Pacific Accessory Corporation

-Displaying video on far rear screen in applicable vehicles

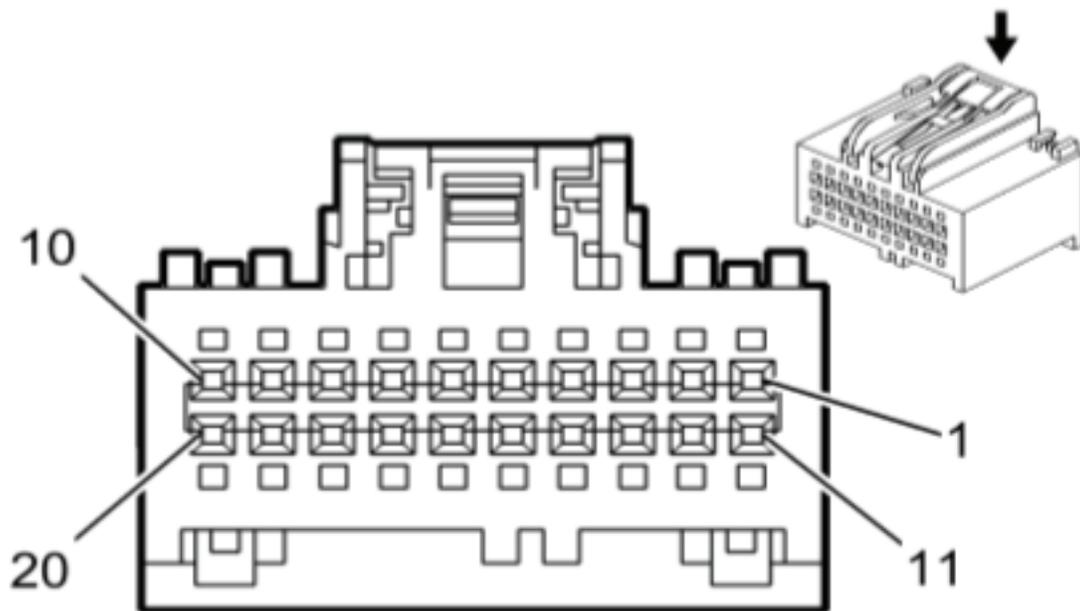
Symptoms: Video is not displayed on far rear screen.

Reason: We have found that there is a separate video feed for the far rear screen.

Solution: Below is a picture of the connector in which four wires need to be connected for video to be displayed on the far rear screen. For reference this is the male connector on the GMRVD2 harness and the pin view is from the wire side (see image with arrow for reference).

Pin 8 needs to be spliced with Pin 10

Pin 18 needs to be spliced with Pin 20

Pin 8 - Lt. Green - Screen 2 Video +
Pin 10 - Green/Black - Screen 1 Video +
Pin 18 - White - Screen 2 Video -
Pin 20 - White/Black - Screen 1 Video -
